MEMORANDUM

Revised Master Plan and Phase I Development Plan for Laurel Rock Reserve Major Subdivision (2008-M11)

Henderson County Planning Department Staff Report

Revised Master Plan & Phase I Development Plan for Laurel Rock Reserve (2008-M11)

Map B: Slopes Map

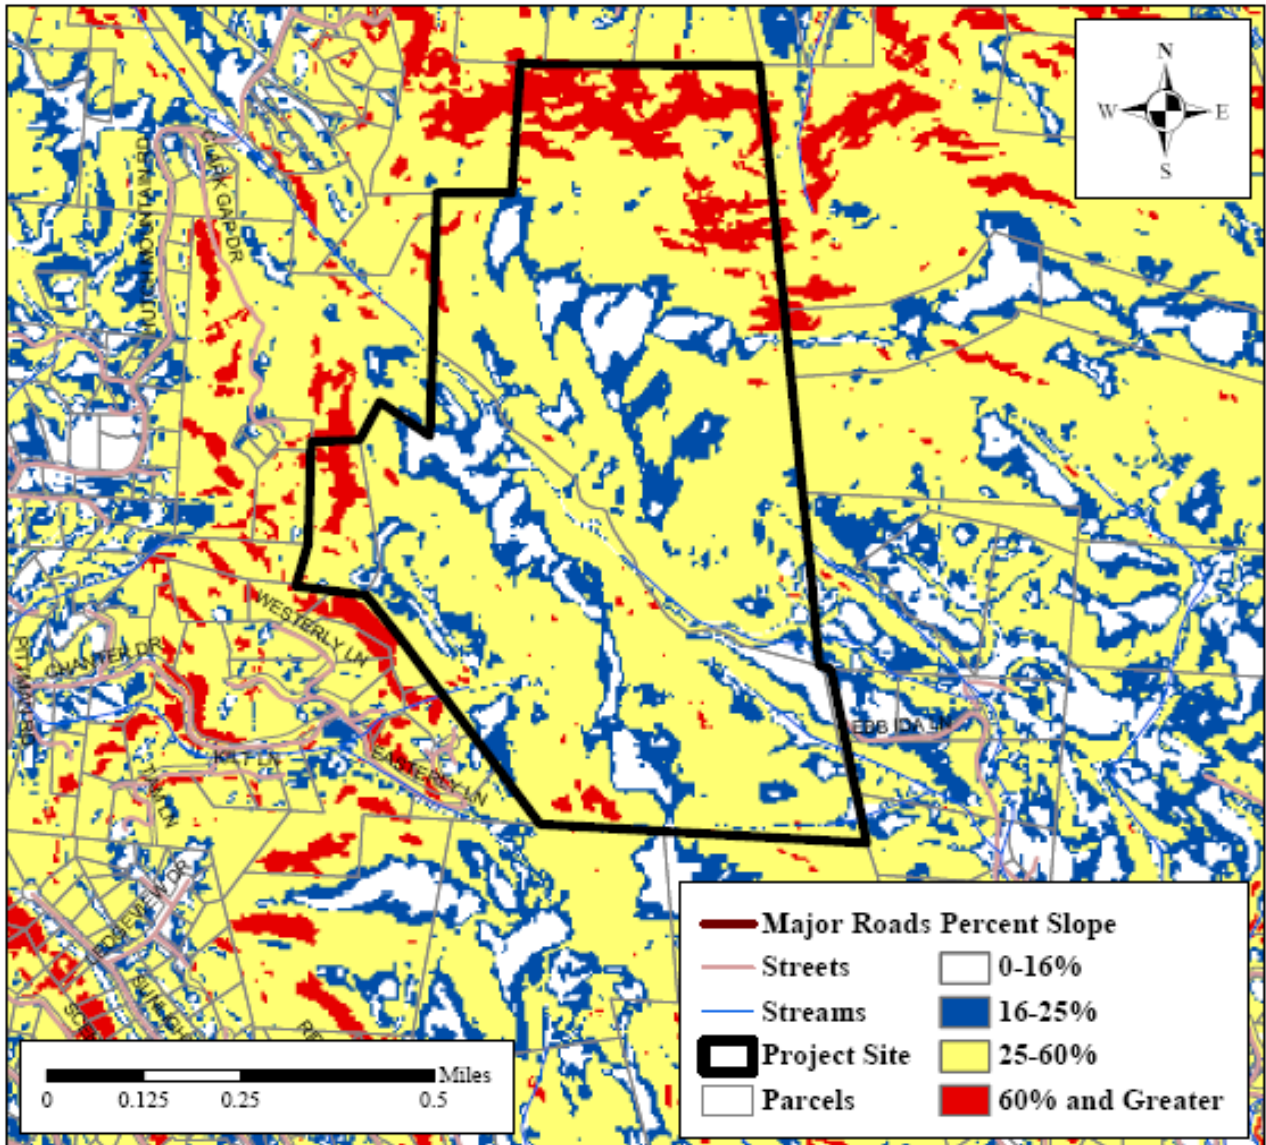
- (a) **Conservation Area.** The conservation area designation is applied to a majority of the project site, largely due to slope and a protected mountain ridge (See Map A: CCP Future Land Use Map, Map B: Slopes Map, and Map C: Protected Ridges). Slopes within the project site appear to be in excess of 25 percent, with portions having slopes in excess of 60 percent. According to the plan, a majority of the steep slope areas within the project site appear to be located in designated common area/open space and are not currently proposed to contain single-family development. The CCP states that conservation lands "are intended to remain largely in their natural state, with only limited development," and further that "such areas should be targeted for protection through regulations and incentives" (2020 CCP, Pg. 134). Under the currently approved Master Plan, 26 lots contain slopes in excess of 60 percent with a condition that where possible, the Applicant shall reconfigure lots and alter the design of the development so that slopes in excess of 60 percent remain in common area/open space. Lots which contain slopes in excess of 60 percent now include the following 21 lots: 9, 17, 23, 32, 70, 71, 91, 99-101, 119, 123-126, 129-134 (See Attachment 8, Revised Master Plan). Should the Technical Review Committee wish to recommend approval of the Revised Master Plan, Planning Staff again recommends that, where

possible, the Applicant reconfigure lots and alter the design of the development so that slopes in excess of 60 percent remain in common area/open space.

Map C: Protected Ridges Map

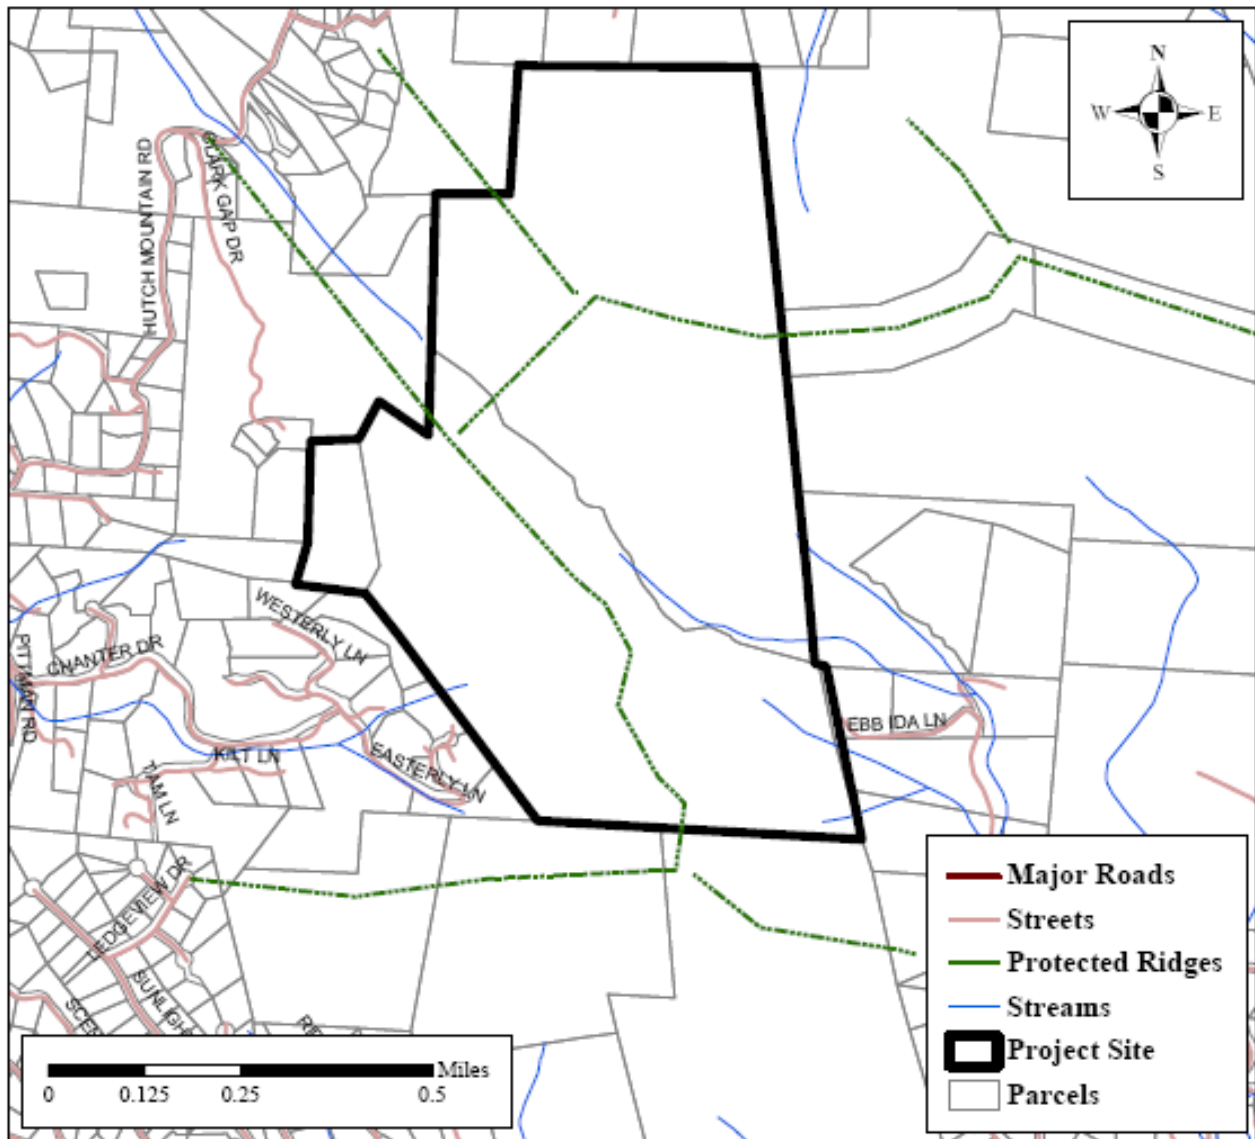
2. **Protected Mountain Ridges.** The project site appears to contain areas effected by the Mountain Ridge Protection Ordinance which states that the provisions of NCGS 113A-209 apply to all mountain ridges in Henderson County whose elevation is 500 feet or more above

the adjacent valley floor (Map C: Protected Mountain Ridges). NCGS 113A-209 states that no county may authorize the construction of, and no person may construct, a tall building or structure on any protected mountain ridge. The definition of a tall building found in NCGS 113A-206 is any building with a vertical height of more than 40 feet measured from the top of the foundation and the uppermost point of the building. Additionally, where such foundation measured from the natural finished grade of the crest or the natural finished grade of the high side slope of a ridge exceeds three (3) feet, then such measurement in excess of three (3) feet shall be included in the 40-foot limitation provided that no such building protrudes at its uppermost point above the crest of the ridge by more than 35 feet. The area of ridge under protection is defined as the elongated crest or series of crests at the apex or uppermost point of intersection between two (2) opposite slopes or sides of a mountain, and includes all land 100 feet below the elevation of any portion of such line or surface along the crest. Planning Staff again recommends, as a condition of approval, that the Applicant shall adhere to the Mountain Ridge Protection regulations of the County which state that the provisions of NCGS 113A-209 apply to all mountain ridges whose elevation is 500 feet or more above the adjacent valley floor.

Map D: Official Zoning Map

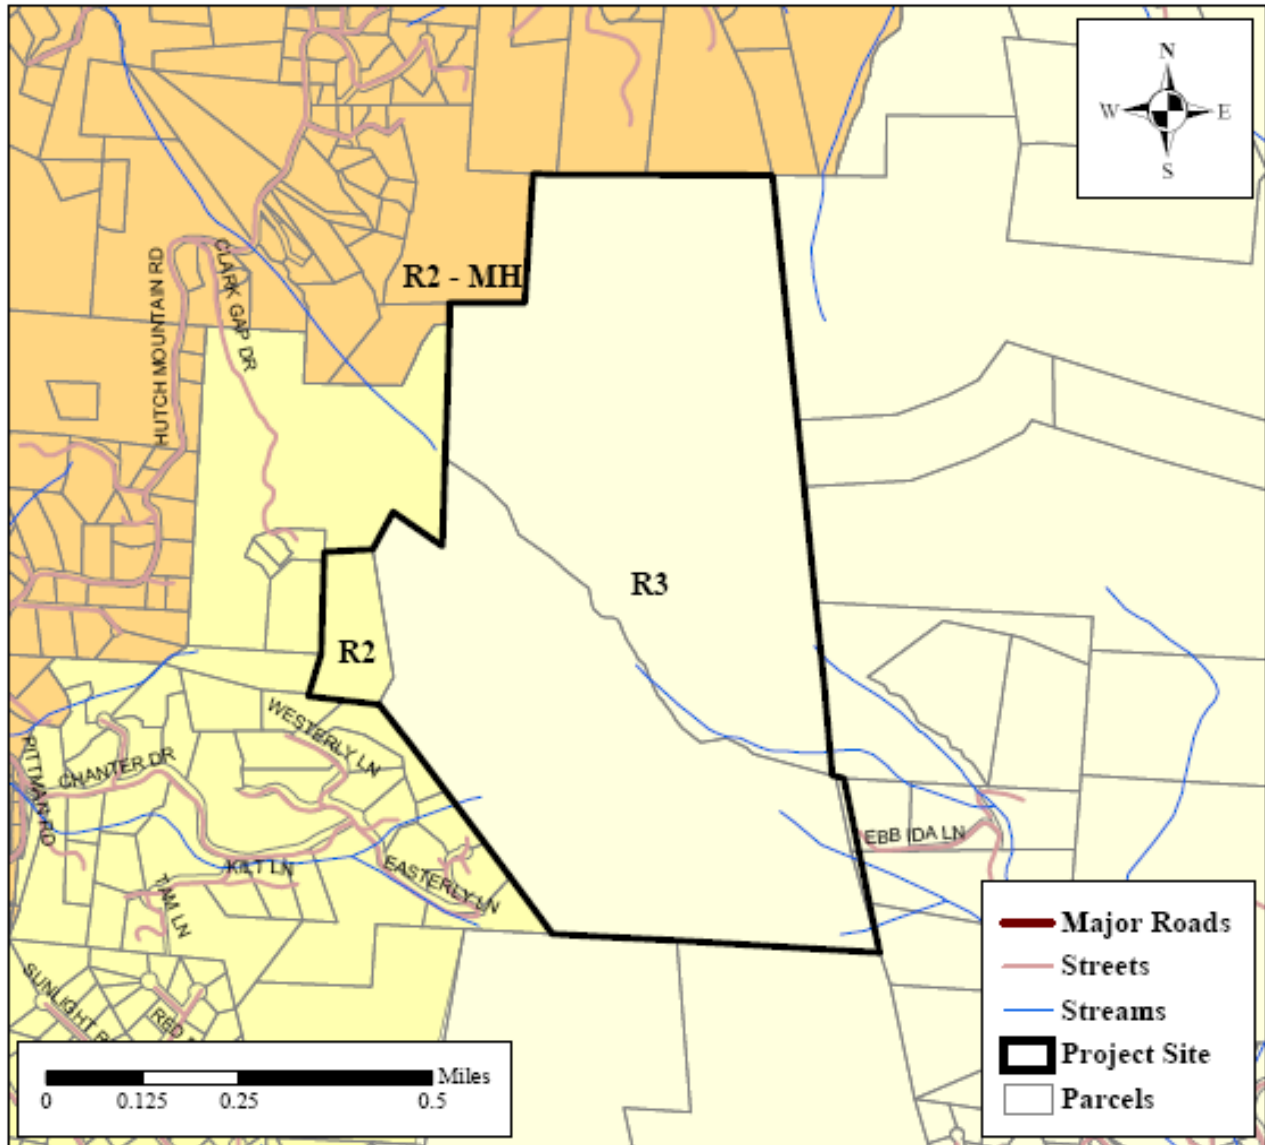
3. **Chapter 200A, Henderson County Land Development Code (LDC).** According to Chapter 200A, Henderson County Land Development Code (LDC) and its Official Zoning Map adopted September 19, 2007 (as amended), the proposed project site is located within both the Residential Two (R2) and Residential Three (R3) Zoning Districts (See Map D: Official Zoning Map). The R2 and R3 district allows for single-family residential development.

Tract 1, which includes 10.28 acres, is located in the R2 Zoning District. R2 allows for a standard residential density of 1 unit per acre (average lot size of 1 acre) where the slope is less than 60 percent. A total of 7.7 acres of Tract 1 are in this category, meaning a total of 7.7 units would be permitted. Where slopes are 60 percent or greater the density shall be on-half (½) the eligible density (0.5 units per acre (average lot size of 2 acres)). A total of 2.58 acres of Tract 1 are in this category, meaning a total of 1.29 units would be permitted. The total number of units permitted by Tract 1 are 8.99 (See Table 1).

Tracts 2 and 3, which include 299.57 acres, are located in the R3 Zoning District. R3 allows for a standard residential density of 0.66 units per acre (average lot size of 1.5 acres) where the slope is less than 60 percent. Tracts 2 and 3 contain slopes in excess of 60 percent, but they do not account for ten (10) percent or more of the tract, therefore the density reduction does not apply. A total of 299.57 acres of Tract 2 and 3 are in this category, meaning a total of 197.71 units would be permitted (See Table 1).

Chapter 200A would allow for a maximum of 206 units on the project site. The Revised Master Plan proposal of 137 units (reduced from the currently approved 149 units) would fall within the density permitted by Chapter 200A (See Table 1).

SHEET S2

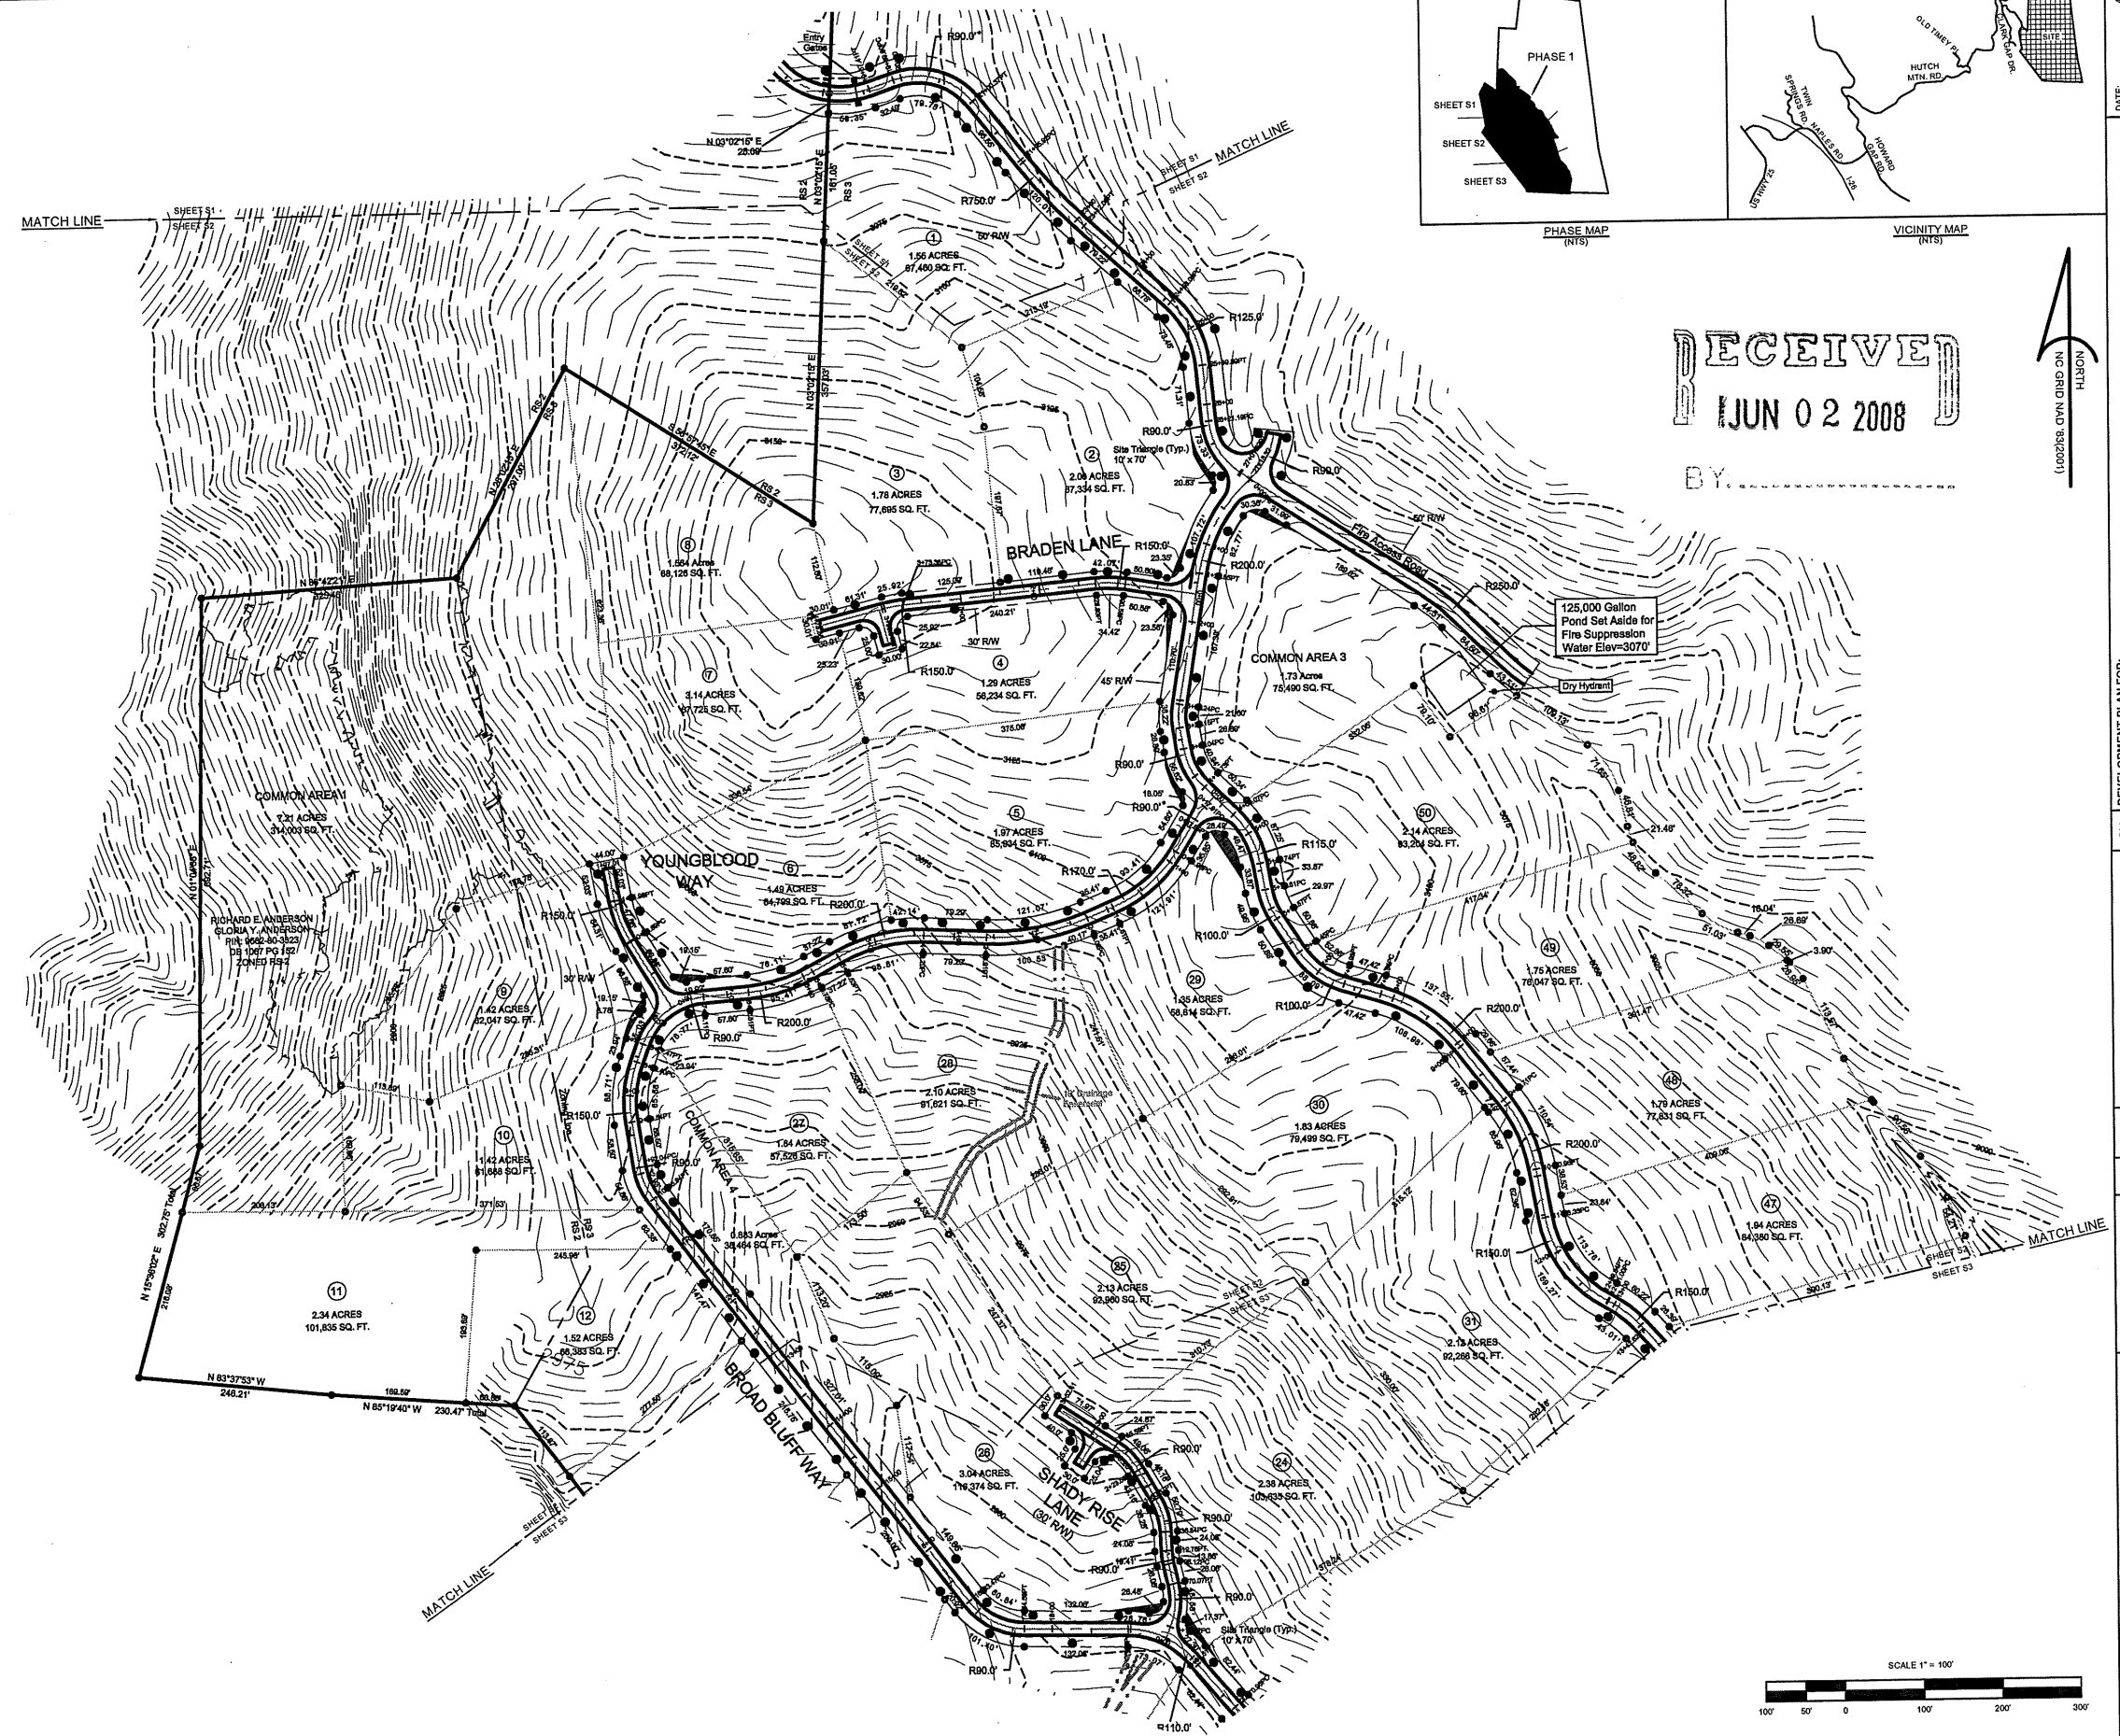
2. **Fire Protection Requirements.** According to LDC §200A-81 B(3), for any *subdivision* without a fire suppression rated water system, that either has or has access to an adequate permanent surface water supply (100,000 gallon storage in a 50 year drought), the *Applicant* shall be required to install a dry fire hydrant system, the type and location of which is to be determined by the County Fire Marshal. An all-weather access *road* for fire-fighting equipment shall be provided by the *Applicant* to this permanent surface water supply. The Planning Board required, as a condition of the current Master Plan approval, that the Applicant shall provide a pond with a surface storage area of at least 100,000 gallon storage in a 50 year drought with two (2) certified static water points (accessible by an all-weather access road) and a dry fire hydrant system, the type and location of which is to be determined by the County Fire Marshal. This condition should be extended to the Revised Master Plan approval. The Phase I Development Plan includes a 125,000 gallon pond set aside for fire suppression which is to be accessible by a proposed all-weather access road within a proposed 50 foot right-of-way (See Attachment 9, Phase I Development Plan Sheet S2).
